## Appendix H. Outreach Report

# METROPOLITAN BRANCH TRAIL PINEY BRANCH ROAD TO BLAIR ROAD NW

COMMUNITY WORKSHOP #1  
MEETING SUMMARY

**6A.3 and 6B.4 : Neighborhood Bikeway**

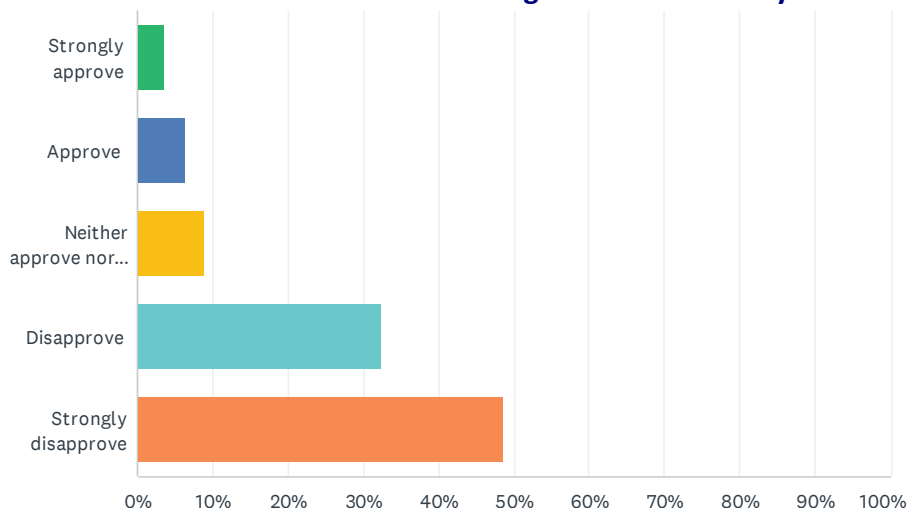
8	This should be a trail-quality PBL on the east side of 4th street. A neighborhood bikeway do not provide a trail-like experience for people walking and biking.	1/7/2022 9:58 AM
9	Unless there is a sign saying: "Bikeway - Cars are Guests", this is just another car dominated road, not a "bikeway", and truly unfit for being part of the MBT.	1/6/2022 10:57 PM
10	if you're gonna do something, do it - this doesn't do anything	1/6/2022 9:58 PM
11	Should be a new multi-use trail on the south side of Whittier St (using park land and DDOT right of way) and a continuous 2-way protected bike lane along the east curb of 4th St. from Whittier to Cedar St (converting 4th one-way southbound and repurposing existing parking)	1/6/2022 7:39 PM
12	I prefer protected bike lanes over the alternatives	1/6/2022 7:16 PM
13	are we trying to make a continuous bike trail or not?	1/6/2022 6:09 PM
14	Not protected bike lane	1/6/2022 3:16 PM

15	Very unsafe. These types of ideas are why bicyclists and pedestrians are dying on DC streets at record rates.	1/6/2022 2:49 PM
16	This is basically nothing and would have no impact on bicycle safety. Please stop calling signage and striping "bicycle boulevards" unless you are actively doing things to ensure 1) low speeds, 2) low volumes AND 3) bicycle priority. You could do this by installing diverters, which allow bicycles to pass but not cars, and installing chokers, chicanes, etc, but I don't see any of that here.	1/6/2022 2:13 PM
17	There is simply too much through traffic to provide for this. Vehicle speeds would need to be artificially reduced, such as with chicanes and speed bumps. This works in narrower streets where parking is not available.	1/5/2022 11:08 PM
18	Sharrows are rarely effective at calming vehicle traffic. Riding in mixed traffic with motor vehicles is not beginner or family friendly. This alternative will dissuade less confident cyclists from choosing alternative modes of transportation. This alternative is less visibly identifiable as a continuation of the trail.	1/5/2022 10:47 PM

38	Again, not a dedicated bike lane, but not as bad as the painted lanes forcing cyclists near car doors and illegally stopped and parked cars.	12/8/2021 2:17 AM
39	I attended the meeting on the Metropolitan Branch Trail (MBT) tonight. For some reason I was unable to make it known in the breakout session that I had comments. But I want to register my opposition to any plan that would take away parking spaces from in front of my house on 4th St NW between Aspen and Whittier. The parking spots on the street here were part of what made buying my house appealing; it was part of the decision to move to 4th Street more than 20 years ago. Taking away parking from residents should not be done lightly. Some of us on the street are aging in place, and moving groceries and other heavy packages from the road to the house is often difficult already. This street is regularly lined with the cars of its residents. Parking is already scarce enough. We do not have an alley in the back for parking. Most houses have two cars, most of which would be displaced. Losing what we have would also cause us to compete for space with the neighbors across the street. I am an avid biker, and delighted that the city is working on connecting the unfinished parts of the MBT from Union Station to Silver Spring. But the segments of 4th Street from Butternut to Van Buren do not get so much traffic that dedicated bike lanes are necessary. This is not like downtown neighborhoods. Marking these streets with stencils indicating bike priority and awareness would be more than sufficient. And it would leave residents with places to park their cars.	12/7/2021 9:51 PM

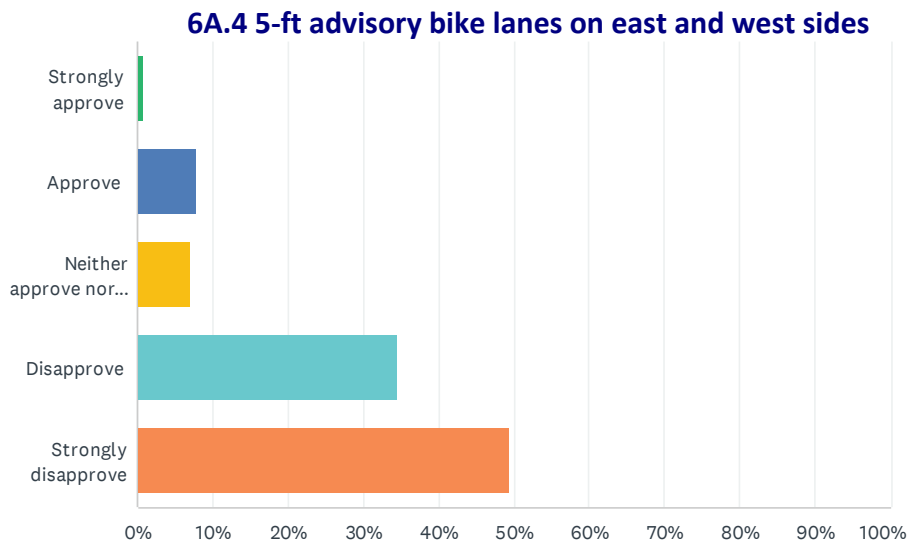
15	Unprotected lanes are not as beginner or family friendly. However, this seems somewhat better than sharrows. Without strong parking enforcement, which so far is not seen in much of the city, the lanes are likely to be frequently blocked by parked and standing vehicles, making the lanes undesirable for less-confident cyclists. It would be better to remove street parking and add protection.	1/5/2022 10:47 PM
16	There should be dedicated, protected, bike facilities along the entire route	1/5/2022 11:25 AM
17	The bike lane on the bottom side of the drawing appears to be in the door zone. To be honest though, I don't know much about advisory bike lanes. Has DDOT seen them work anywhere? How do they overcome the problems of unprotected bike lanes? Do cyclists actually feel comfortable mixing with motorists? Do drivers respect them? These are unanswered questions for me, so I'm curious to hear more from DDOT.	1/5/2022 10:36 AM

21	Does not provide safe separation between drivers and cyclists.	12/21/2021 8:03 AM
22	DMV drivers will have no idea what to do. Do not want.	12/15/2021 7:40 PM
23	Creating what drivers will use as two 12' general traffic lanes is going to encourage speeding and be a disaster.	12/14/2021 3:47 PM
24	Better than nothing, but is truly the bare minimum. Families and children won't (And shouldn't) use this. Crosswalks should be raised	12/14/2021 3:19 PM
25	Too high traffic a street to get away with this	12/14/2021 2:54 PM
26	I do not like the lack of dedicated, protected space for trail users. I wouldn't feel comfortable traveling with my child on this.	12/14/2021 2:14 PM
27	not familiar enough with how advisory bike lanes work in practice in DC	12/14/2021 2:01 PM
28	not protected	12/13/2021 11:21 AM
29	Advisory means the drivers will ignore it unless there's constant enforcement, but MPD refuses to do any enforcement ever.	12/11/2021 1:36 PM

30	These lanes simply do not work and provide no protection for cyclists. These spaces would simply be used for drivers to stop their car, park, or otherwise drive in.	12/10/2021 5:12 PM
31	The minimum standard on the MBT or other major trail should be a protected bike lane for on-street cycling. Also, both the north and south-bound lanes of the trail should stay on the east side of 4th Street to avoid forcing the south-bound cyclists to cross to the west side of 4th Street, only to have to cross back across 4th Street a block or two later.	12/9/2021 3:09 PM
32	Better than nothing, but more should be done to guarantee bicycle safety, specifically protected bicycle lanes.	12/8/2021 1:44 PM
33	Not nuts about this idea. Still the parked car problem plus cars in the bike lane.	12/8/2021 2:17 AM
34	Removing parking from residents is a bad idea, and is not necessary on 4th St. The introduction to this survey makes it seem like "Advisory bike lanes" do not take away parking. I favor the MBT, I do not want to lose my parking spaces, and I don't want that for my neighbors.	12/7/2021 9:51 PM

6B.6 and 6B.7 and 6B.8: Neighborhood bikeway

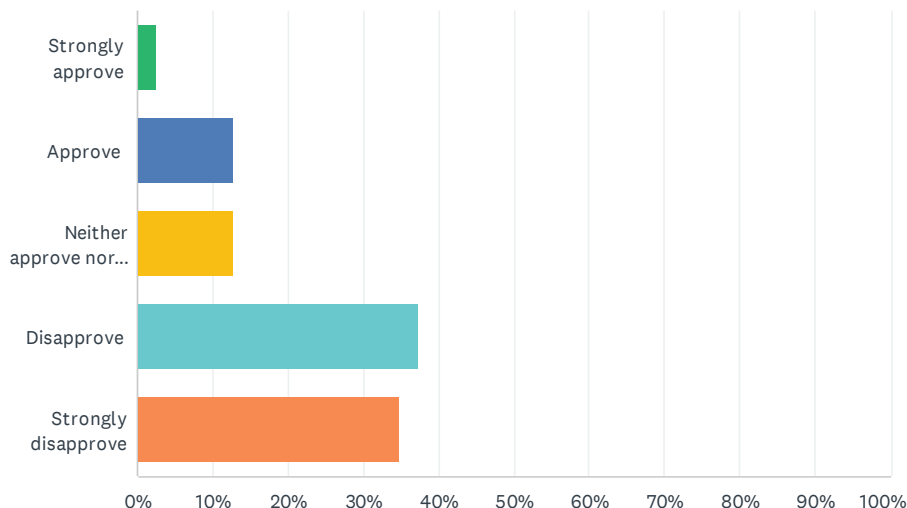
12	Not clear enough separation. Requires riding in door zone. Accidents will happen.	1/6/2022 7:34 PM
13	I would prefer a multi-use trail or protected bike lanes.	1/6/2022 7:20 PM
14	bikeways aren't trails	1/6/2022 6:17 PM
15	A bicycle boulevard needs: 1) low speeds, 2) low volumes, and 3) bicycle priority. I see very little here to ensure any of these. Add aggressive chokers, chicanes, and diverters that filter permeability and allow bicycles to pass but not cars, and you'll have a much better plan.	1/6/2022 2:16 PM
16	Recognize that biking must be put on a par with driving and make the appropriate changes. Make Aspen one way with a parking protected bi-directional bike lane.	1/6/2022 12:39 PM
17	This trail is a critical intercity/regional transportation connection for people on bikes, and all segments should be separate (including protection/barriers) from vehicular traffic.	1/6/2022 10:49 AM

**6A.6: 5-ft one-way bike lanes**

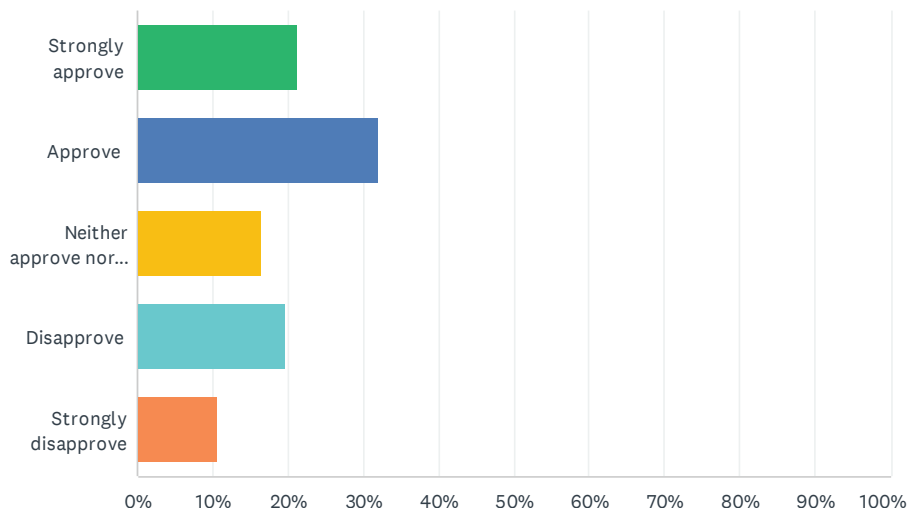
15	The markings will be viewed as optional parking areas. in the same width, the street can be converted to one-way, and a bi-directional cycle track can be installed. Shared space is hazardous.	1/5/2022 11:12 PM
16	There should be dedicated, protected, bike facilities along the entire route	1/5/2022 11:26 AM
17	Alt 2 is way better since it gives cyclists dedicated space. Glad to see that unlike other drawings, this one does not show bike lanes in the door zone. Protection should be added though (bollards or low concrete berms like you see on Irving Street by the hospital).	1/5/2022 10:38 AM
18	too many places for collisions to occur	1/5/2022 10:36 AM
19	This is an improvement over Alternatives 1 and 3, but it is not physically protected or separated from vehicle traffic, and will not encourage biking for people of all ages and abilities. Proposals exist to create a multi-use trail on the south side of Whittier using park land and DDOT right of way that would create a proper, safe segment of the MBT.	1/4/2022 5:21 PM

35	I'd remove the parking on the south side of the street — there's tons of street parking for the park and that would avoid residents walking across the street.	12/11/2021 1:42 PM
36	See comments from above. Cyclists would not be safe crossing around Blair and Aspen.	12/10/2021 9:42 PM
37	The bike lanes for MBT and any other major trail should be protected.	12/9/2021 2:40 PM
38	Something has to be done. Aspen is backed up to Fourth Street at rush hour and pedestrians on the sidewalks worry about their safety with cars speeding through at all hours. The speed hump helped, but I've seen cars hit it going +40 and then just accelerate again. Anything that distances pedestrians from the speeding cars is better than what we have now.	12/8/2021 3:12 PM
39	I VERY STRONGLY disapprove of the plan to remove parking on the north side of Aspen Street, which is normally completely full with resident parking. This would be a disservice to residents in the neighborhood.	12/8/2021 1:09 PM

40	Lanes should be painted green.	12/8/2021 2:25 AM
41	Dedicated space. Safest for bike riders and especially children on bikes.	12/7/2021 9:34 PM
42	This would be a good solution in addition to solution 1 on Van Buren.	12/7/2021 8:58 PM
43	This block is heavily parked, including by seniors who live on this block, and proposing to remove it will anger a lot of people. As another potential alternative, I would like to see DDOT consider cutting over to Blair on Butternut	12/7/2021 8:57 PM
44	This design looks best.	12/7/2021 8:52 PM
45	Could a variation on Alternative 2 be to offer a dedicated bike lane but with east-bound and west-bound bike lanes sharing the same side of the street? I fear separating the lanes will lead to confusion among bicyclists— especially if the lanes are adjoining on 4th Street and on Blair.	12/7/2021 8:50 PM

**6A.7 and 6A.8: 5-ft advisory bike lanes on north and south sides**

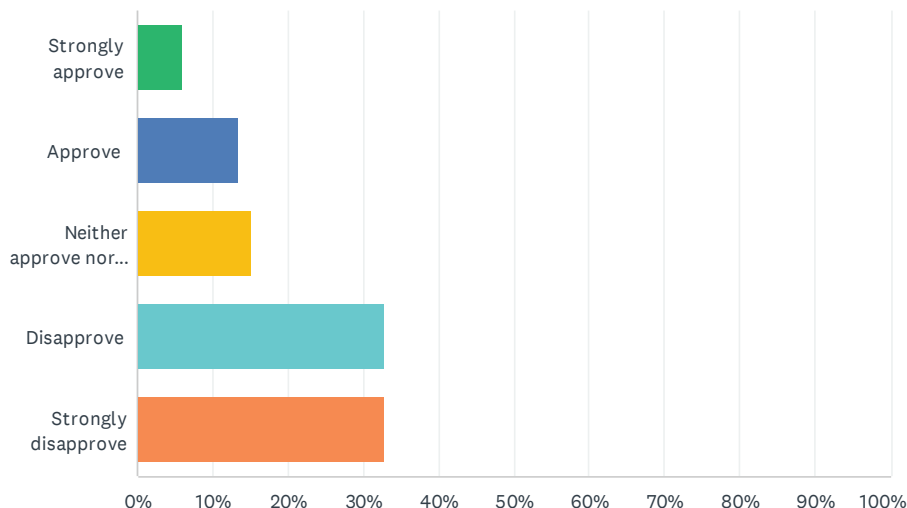
36	There should be protected bike lanes.	12/13/2021 9:18 AM
37	Advisory bikelanes are routinely ignored by drivers. If it doesn't have a physical barrier, it'll be used for passing or parking.	12/11/2021 1:42 PM
38	The bike lanes for MBT and any other major trail should be protected. The trail should be taken off the street and routed along the edge of the city park on the south side of the 300 block of Whittier.	12/9/2021 2:40 PM
39	Of the options that remove parking, which I disapprove of, this is a better option, because the parking in these areas is not taken up as often as on the north side of Aspen street.	12/8/2021 1:09 PM
40	It's already difficult finding parking along this street, especially with the high use of the park facilities that attract large groups of visitors during weekends. This would significantly burden residents without off-street parking.	12/8/2021 1:07 PM
41	Parked cars along bike lane. Other traffic.	12/8/2021 2:25 AM

45	As a driver and a cyclist, I would be very concerned about the idea of an Advisory Bike Lane causing confusion and accidents. I really don't understand where the cars ago and how they pass each other. At times there is far too much traffic on these streets for this to work.	12/7/2021 8:52 PM
46	This would eliminate parking around the park, which fills up quickly on weekends when the fields are in use.	12/7/2021 8:42 PM
47	I strongly disapprove of making Whittier the primary connection between 4th St and Blair. I live at the corner of 3RD and Whittier, and the Ft. Totten to Takoma project is already taking part of our yard and reducing our privacy. I'm an avid cyclist and a strong supporter of the Met Branch Trail, but this is too much of an impact to our property. Additionally there is no signal at Blair and Whittier, but there are signals at Aspen and Van Buren.	12/7/2021 8:39 PM
48	Strongly disapprove of making Whittier Street the connecting street between Blair Road and 4th Street. My family lives at the corner of Whittier and 3rd and Blair. The Ft. Totten to Takoma project is already taking part of our yard and reducing our privacy. I bike all the time and I am fully in support of the Metropolitan Branch Trail project but I oppose making Whittier Street the connecting street between Blair Road and 4th Street because it directly impacts my property. Additionally, there is no signal at the intersection of Whittier and Blair Road. There are signals at Aspen Street and Van Buren Street.	12/7/2021 8:30 PM
